Laguna Safrane Espace

11 DEVELOPMENT OF THE CAMSHAFT PULLEY SCREW TIGHTENING DIRECTION

- Engine: L7X
- Gearbox: XXX

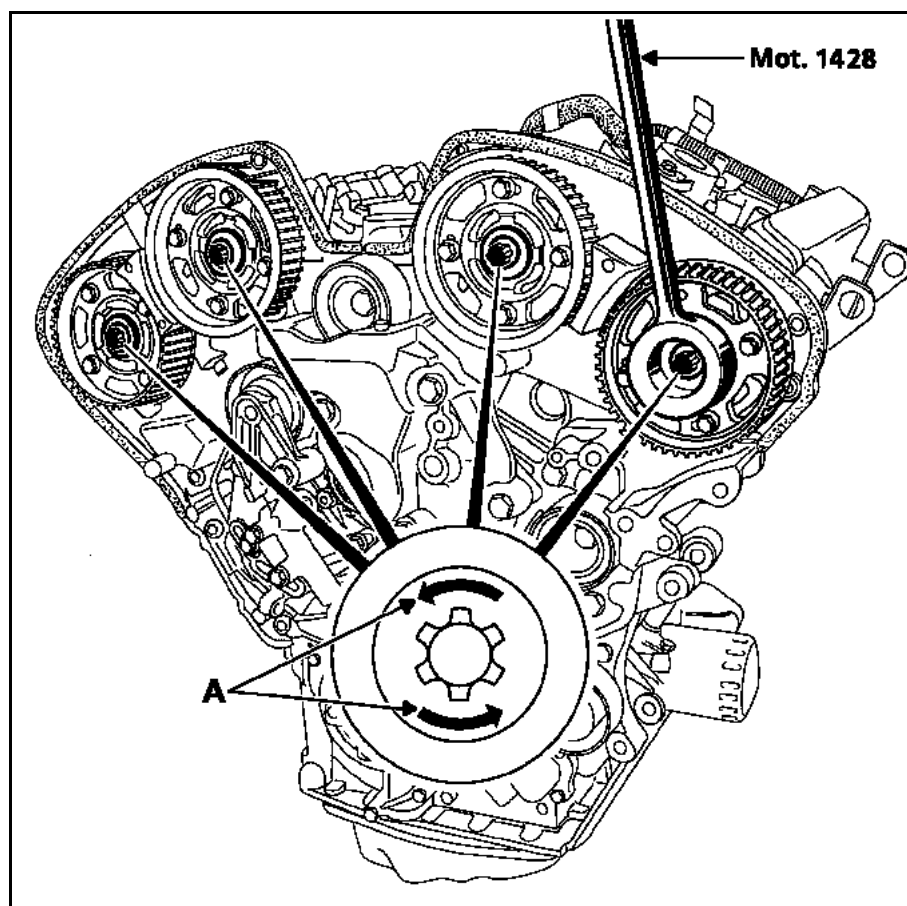
New camshaft pulley screws tightening direction.

These screws have **one pitch on the left**, the arrows (A) on the heads of these screws indicate the tightening direction.
